re: Superseding of Application #301930560
26 Remsen St, Brooklyn, NY (BIN#302119)

26 REMSEN ST.

DOB REPORT

2 PROPOSED PLUMBING DIAGRAM
Scale: N.T.S.

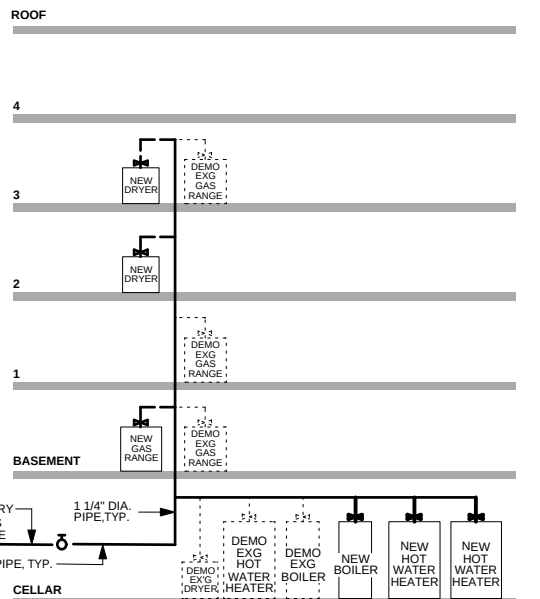
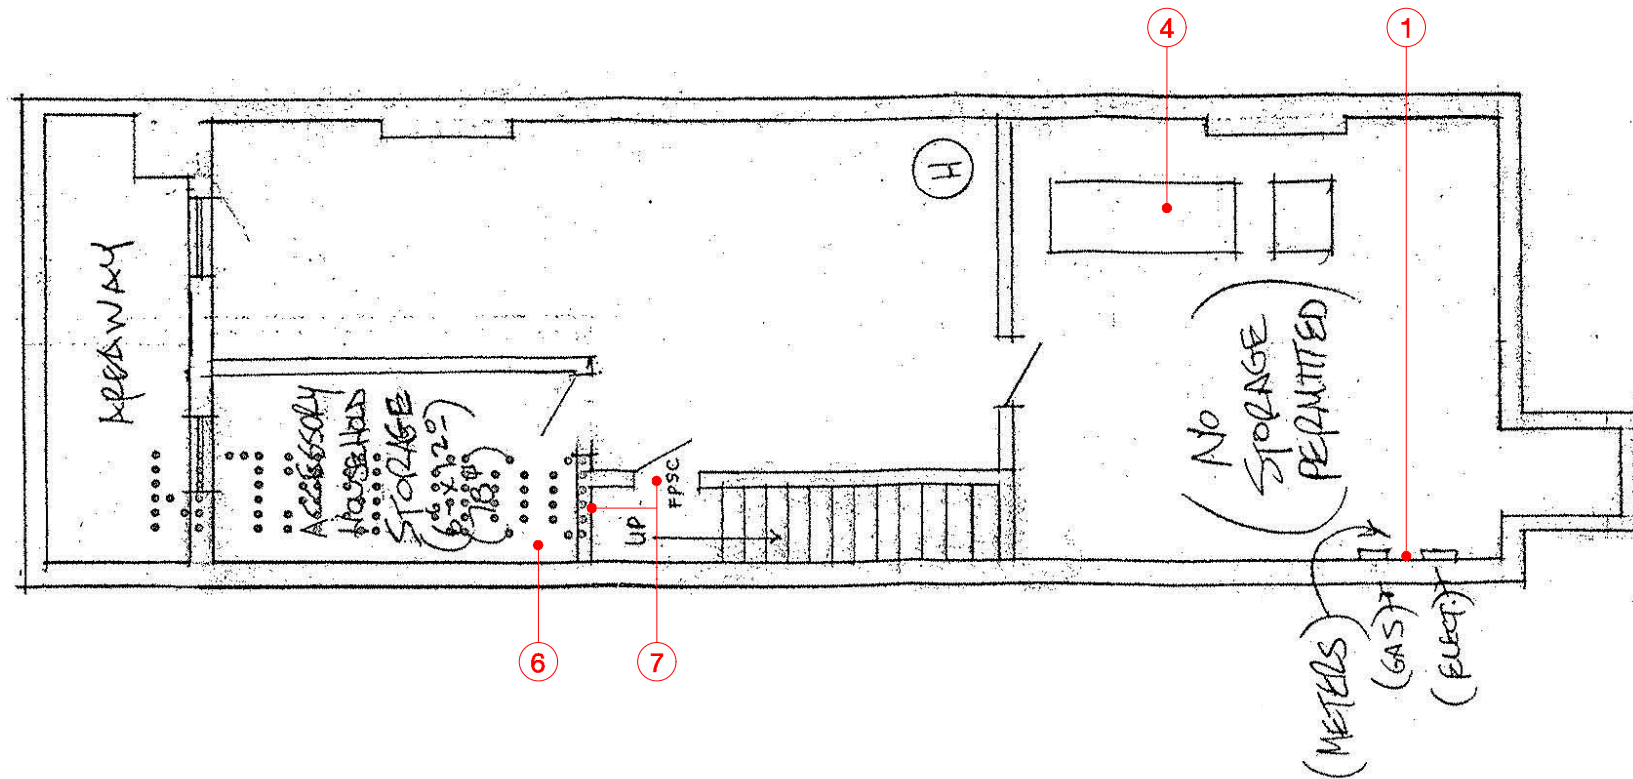
1. GAS RISER DIAGRAM NOT INCLUDED IN PREVIOUSLY APPROVED. ADDED TO PROPOSED.
2. CELLAR FLOOR OF DIAGRAM NOT SHOWN IN PREVIOUSLY APPROVED. ADDED TO PROPOSED.
3. DEMO FIXTURES & APPLIANCES NOT INCLUDED IN PREVIOUSLY APPROVED. ADDED TO PROPOSED.
4. EXTERIOR PLUMBING NOT SHOWN IN PREVIOUSLY APPROVED AND INCLUDED IN PROPOSED.
5. WASHERS SHOWN AT PROPOSED LOCATIONS IN PROPOSED.
6. DISHWASHER INCLUDED IN PROPOSED.
7. ADDITIONAL LAV ADDED TO NEW THIRD FLOOR BATHROOM IN PROPOSED.

PROPOSED PLANS: CELLAR

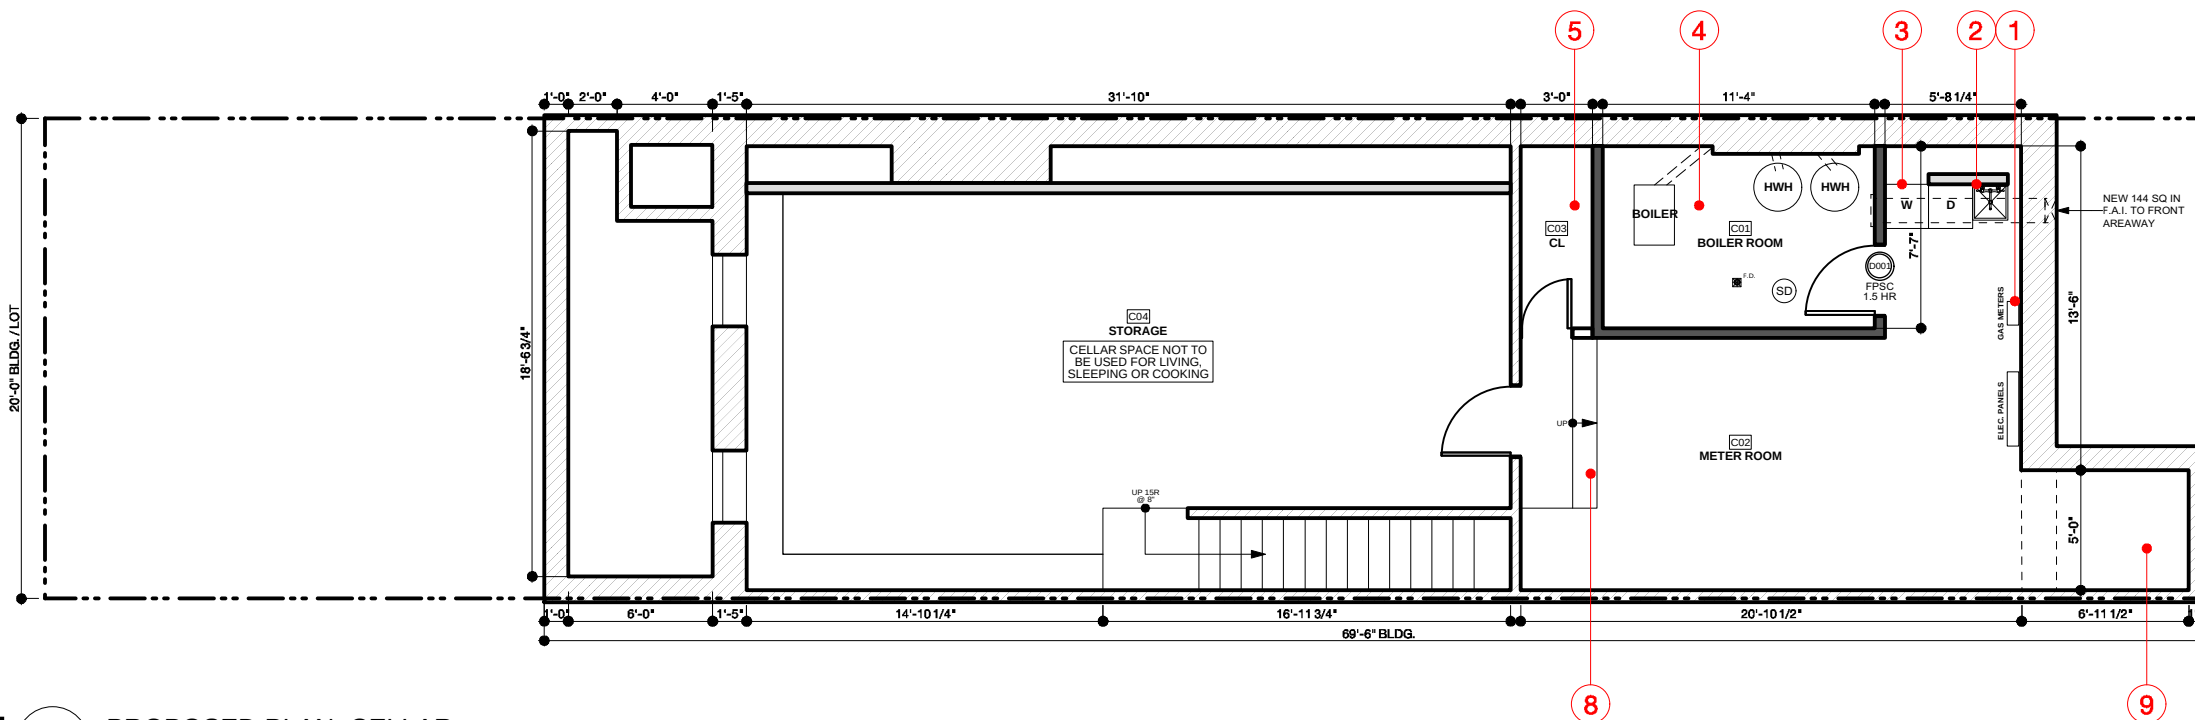
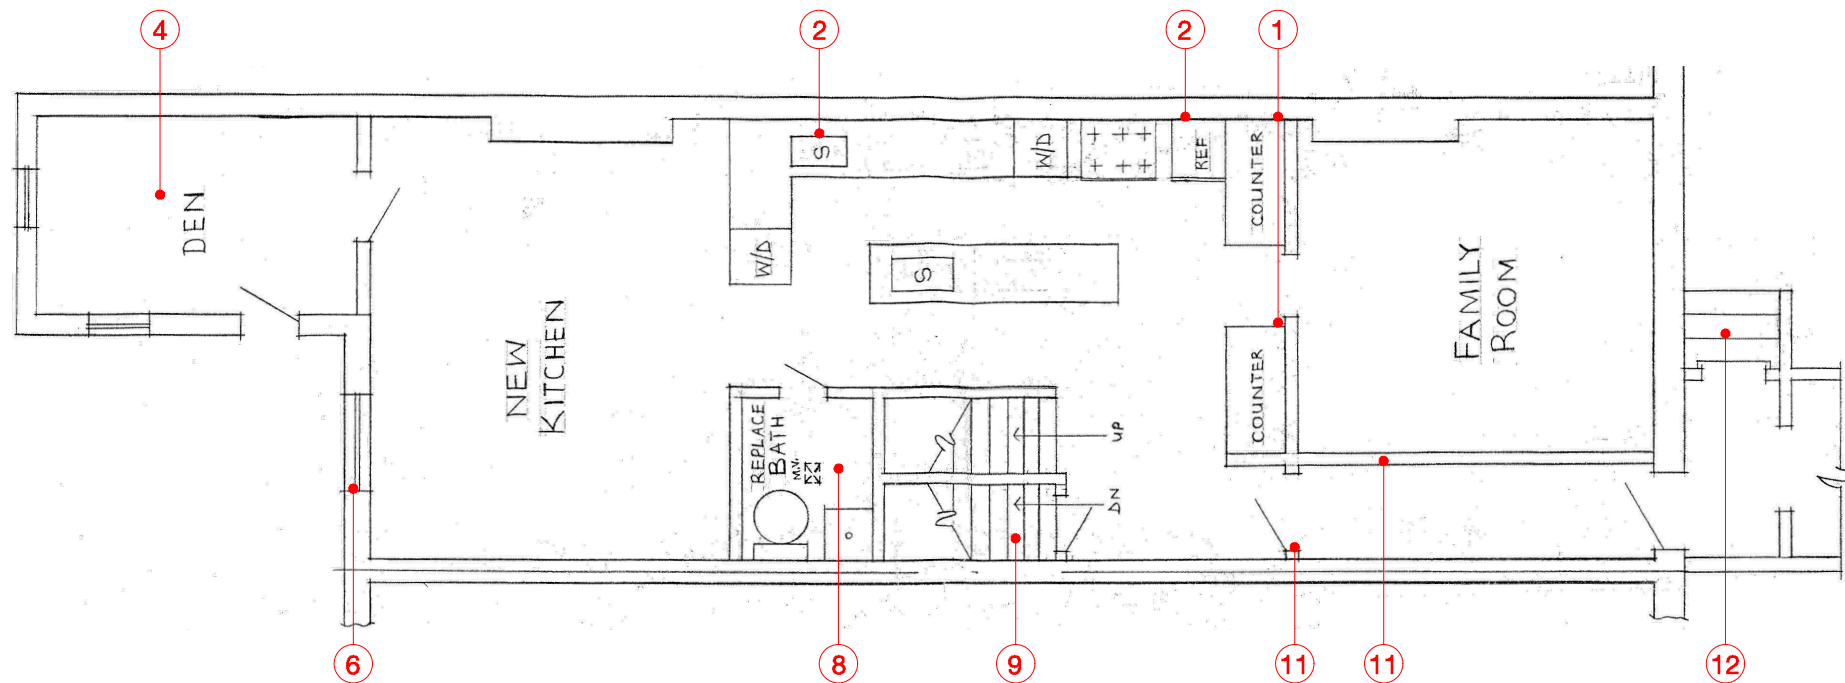
1. METER LOCATION CHANGED TO NORTH ELEVATION IN PROPOSED.
2. UTILITY SINK IN PROPOSED.
3. WASHER & DRYER IN PROPOSED.
4. MECHANICAL ROOM ENCLOSED WITH 2-HOUR FIRE RATED WALLS SEPARATED FROM METERS IN PROPOSED.
5. CLOSET IN PROPOSED.
6. SEPARATED STORAGE SPACE IN PREVIOUSLY APPROVED NOT IN PROPOSED.
7. FPSC DOOR & ENCLOSING WALL SECTION AT BOTTOM OF STAIRS IN PREVIOUSLY APPROVED NOT IN PROPOSED.
8. STEPS UP TO METER ROOM IN PROPOSED.
9. LOCATION OF EXISTING AREAWAY UNDER FRONT HATCH CORRECTED IN PROPOSED.

PROPOSED PLANS: BASEMENT

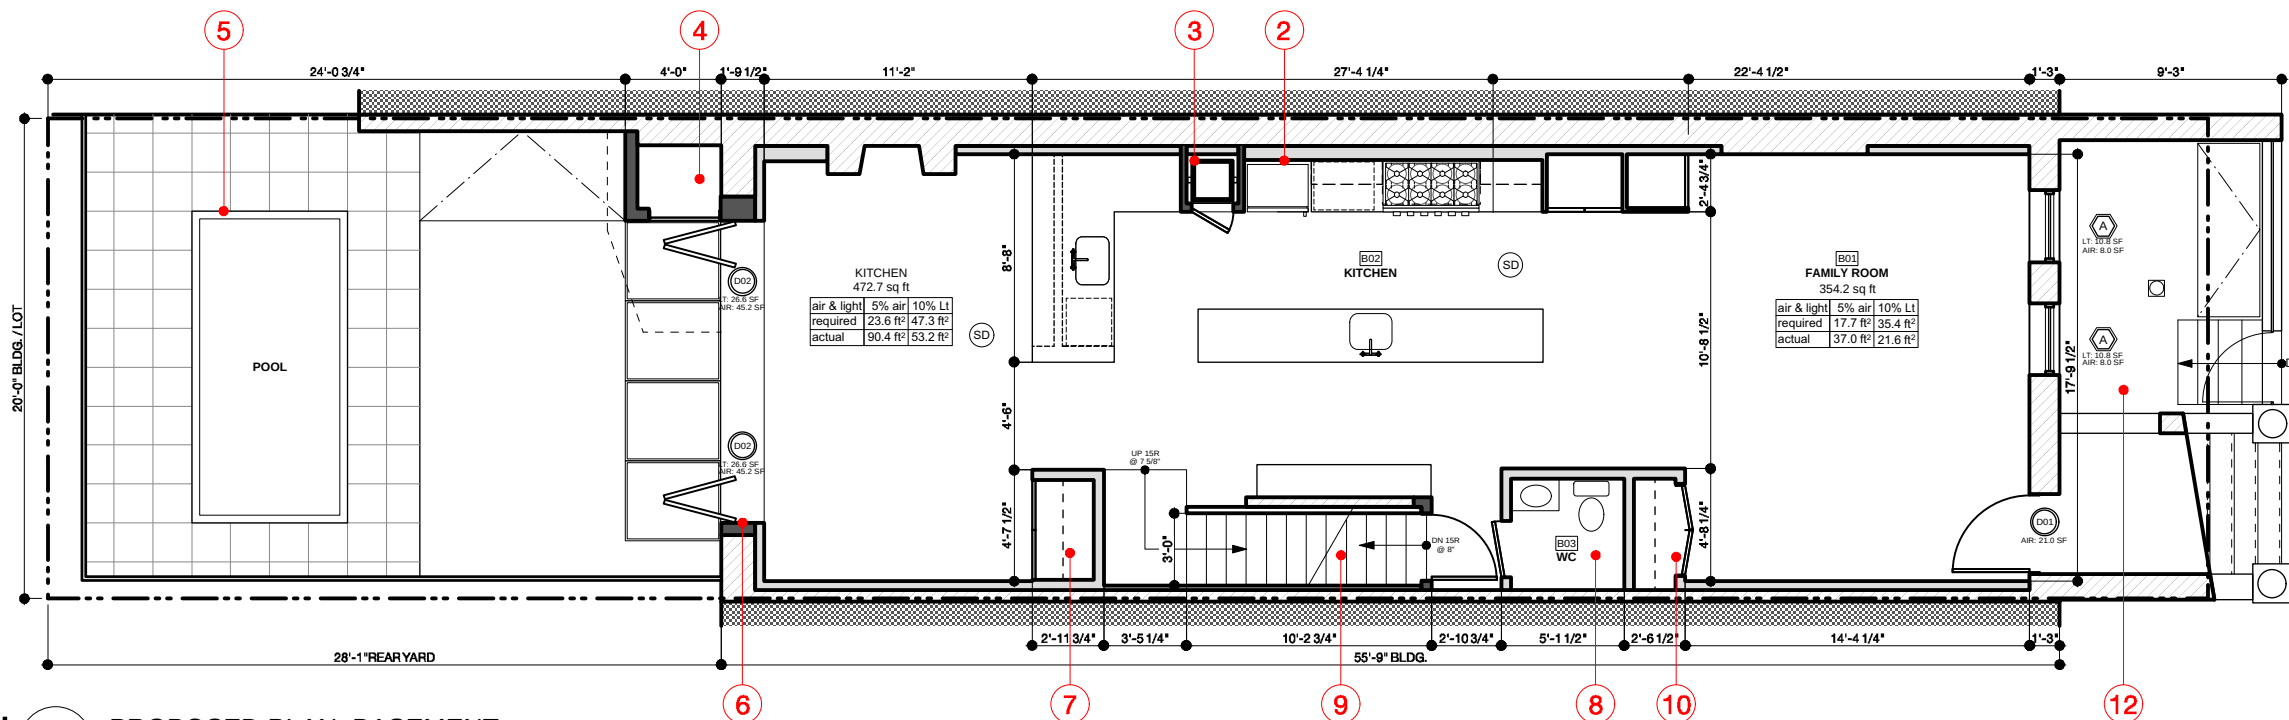
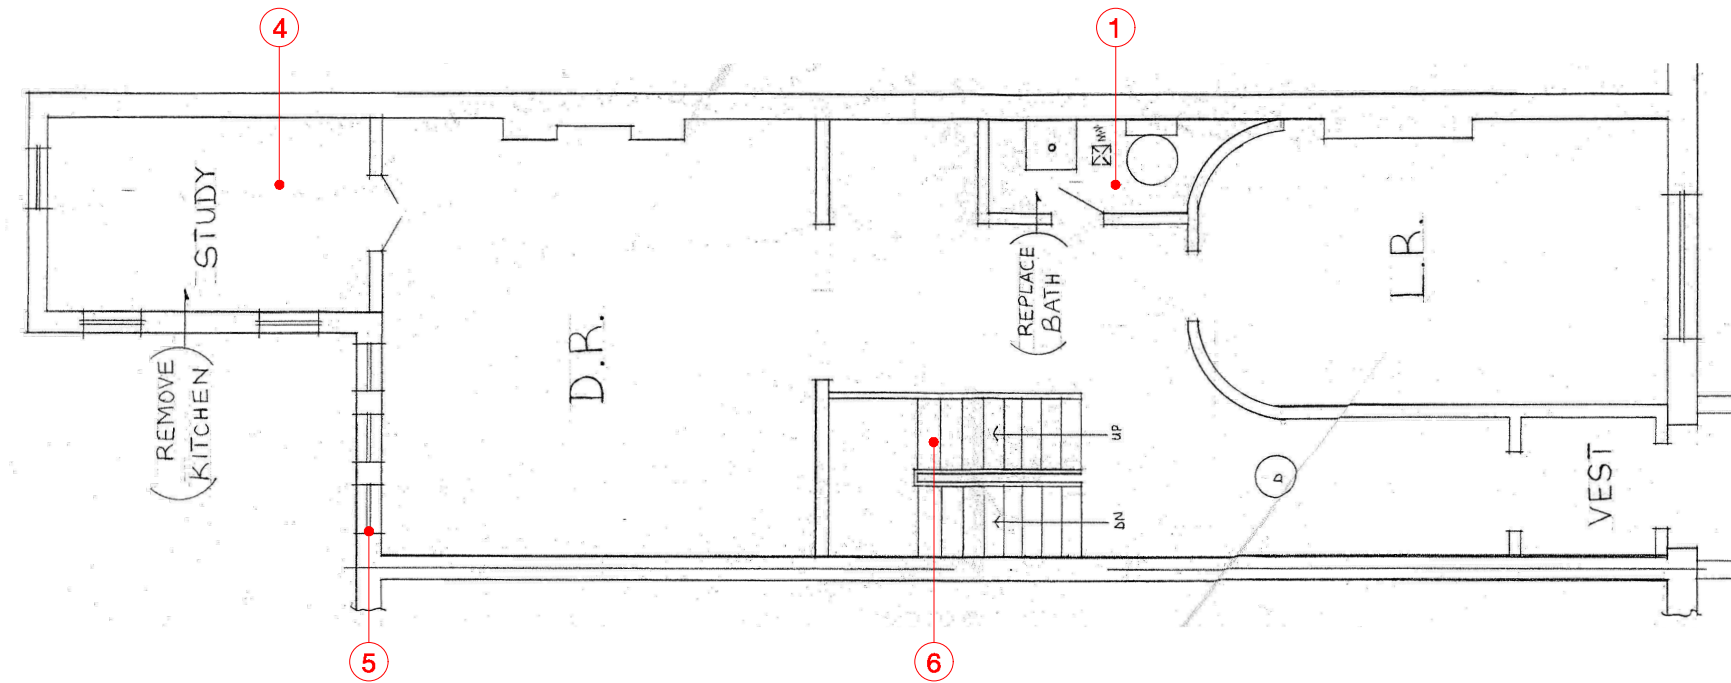
1. WALL & COUNTER SEPARATING FAMILY ROOM & KITCHEN NOT IN PROPOSED.
2. ALL APPLIANCES & PLUMBING FIXTURES IN KITCHEN RELOCATED, & KITCHEN LAYOUT & SIZE MODIFIED IN PROPOSED.
3. DUMBWAITER ADDED TO PROPOSED.
4. DEN EXTENSION IN PREVIOUSLY APPROVED NOT IN PROPOSED. INSTEAD PROPOSES SMALLER EXTERIOR STORAGE CLOSET.
5. NO INGROUND POOL OR REAR YARD PLAN SHOWN NOR INDICATED IN PREVIOUSLY APPROVED.
6. OPENING IN EXTERIOR REAR FACADE CHANGED FROM SINGLE WINDOW UNIT TO LARGE BI-FOLD EXTERIOR DOOR UNIT IN PROPOSED.
7. CLOSET ADDED IN PROPOSED.
8. LOCATION & LAYOUT OF WATER CLOSET CHANGED IN PROPOSED.
9. CONFIGURATION OF STAIRS CHANGED IN PROPOSED.
10. CLOSET ADDED IN PROPOSED.
11. WALLS ENCLOSING ENTRY HALL & INTERIOR DOOR AT HALL NOT IN PROPOSED.
12. CONFIGURATION OF AREAWAY DIFFERENT IN PROPOSED.

PROPOSED PLANS: FIRST FLOOR

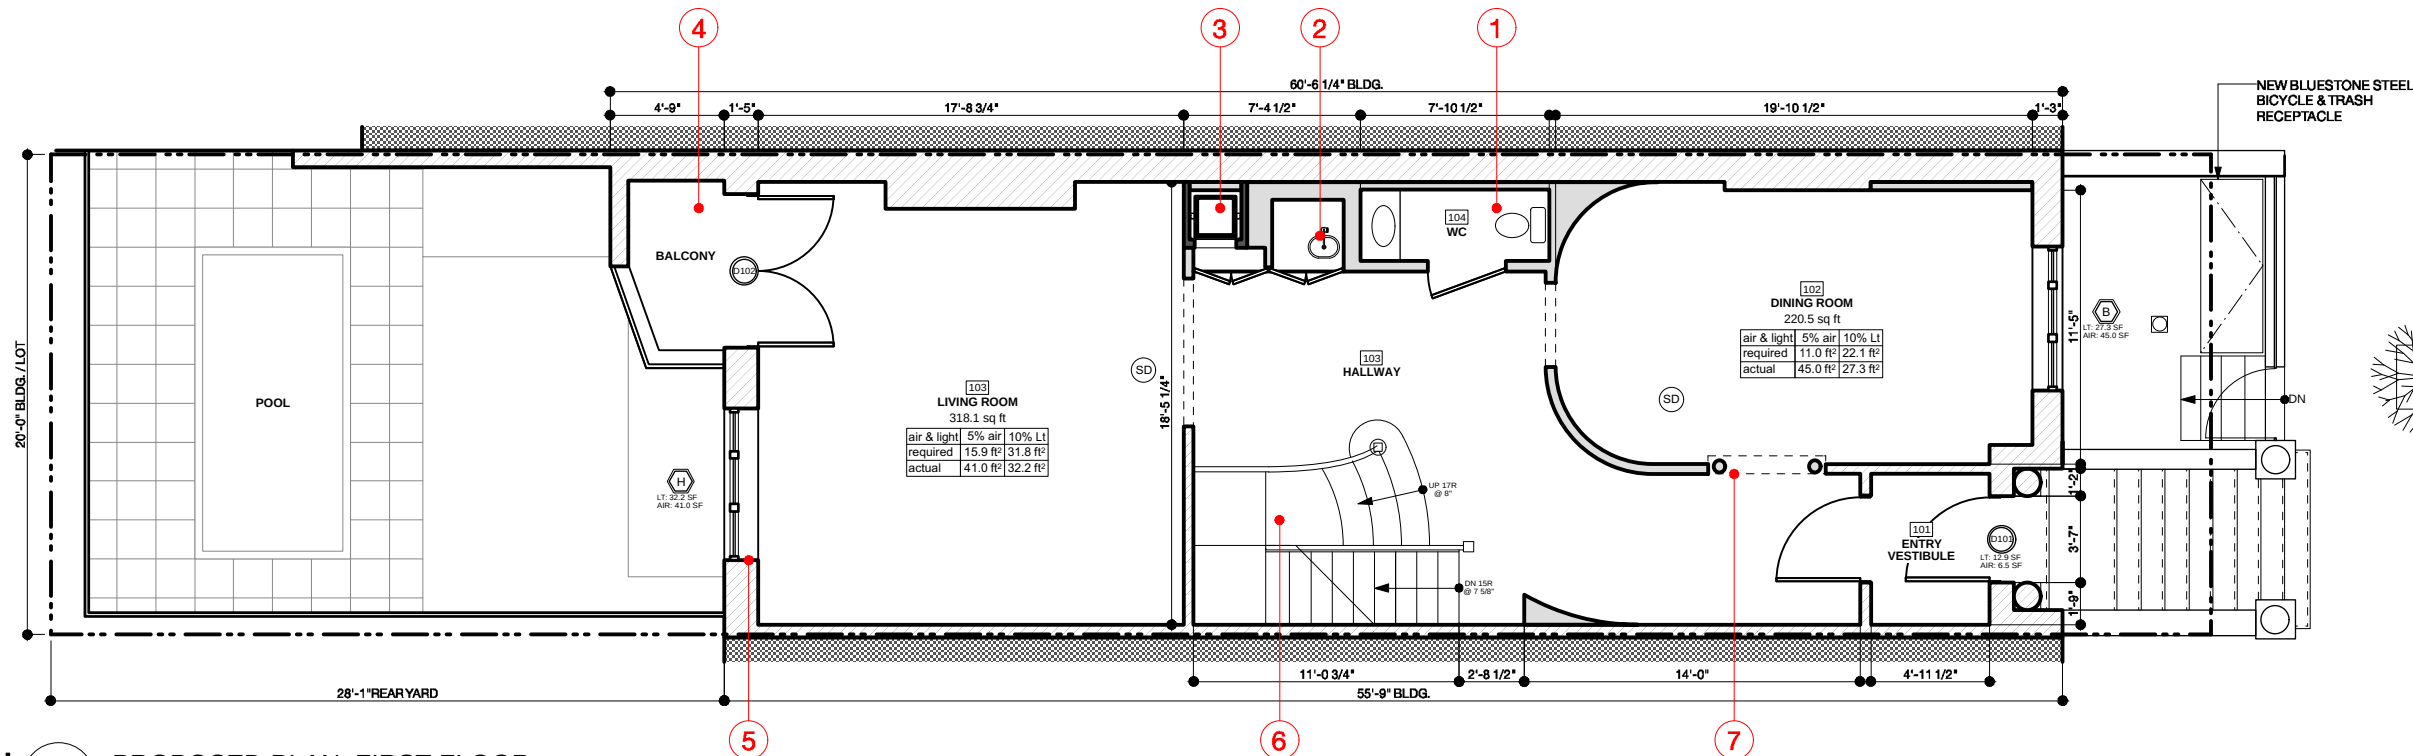
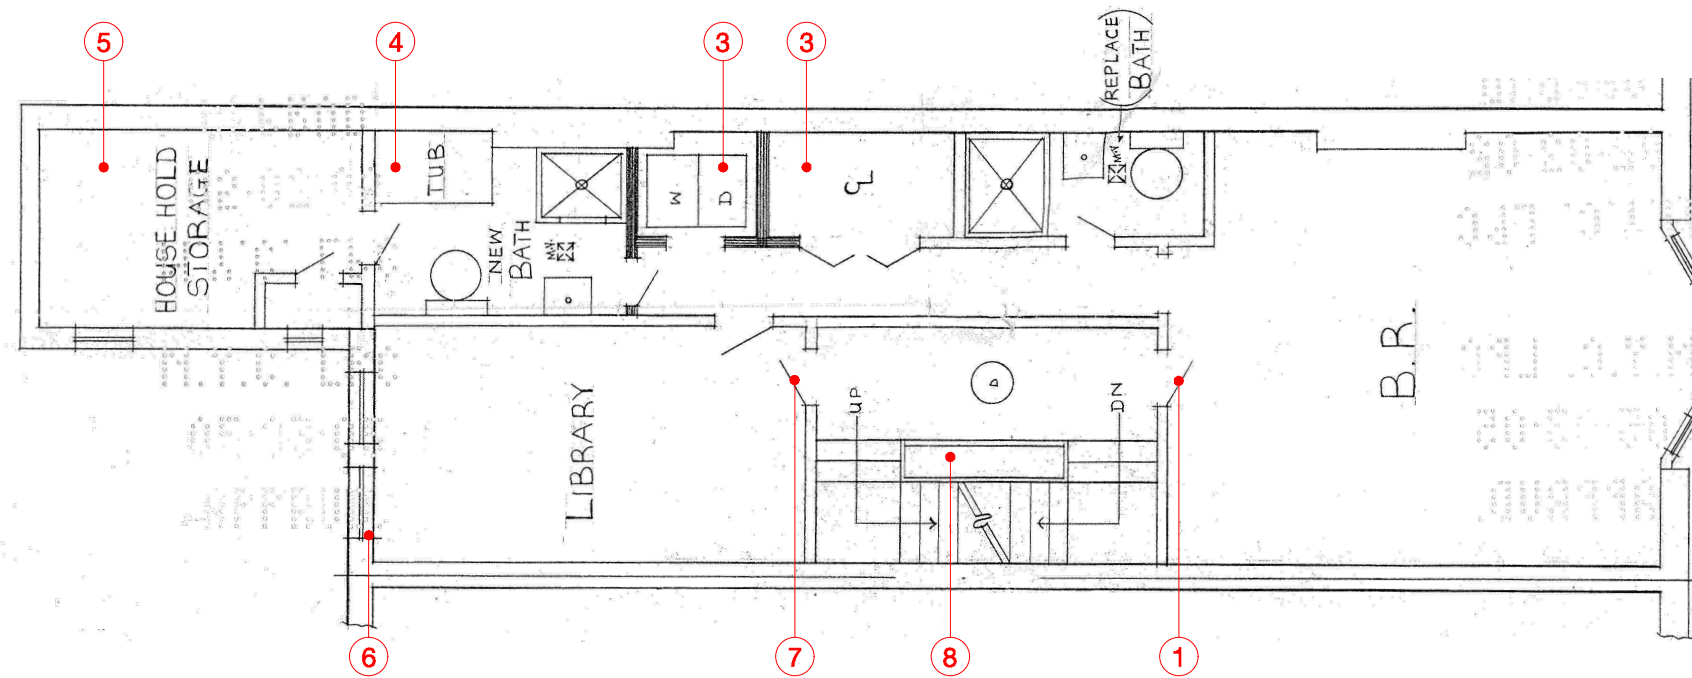
- ### LIST OF REVISIONS
1. WATER CLOSET CONFIGURATION CHANGED IN PROPOSED.
 2. MILLWORK WITH BAR SINK & SINK FAUCET ADDED IN PROPOSED.
 3. DUMBWAITER ADDED TO PROPOSED.
 4. SIZE, LAYOUT & ROOM DESIGNATION CHANGED FROM STUDY TO EXTERIOR BALCONY IN PROPOSED.
 5. REAR FACADE WINDOW CONFIGURATION CORRECTED TO MATCH EXISTING IN PROPOSED.
 6. STAIR CONFIGURATION CORRECTED TO MATCH EXISTING IN PROPOSED.
 7. NEW ADDITIONAL FRAMED OPENING TO LIVING ROOM IN PROPOSED.
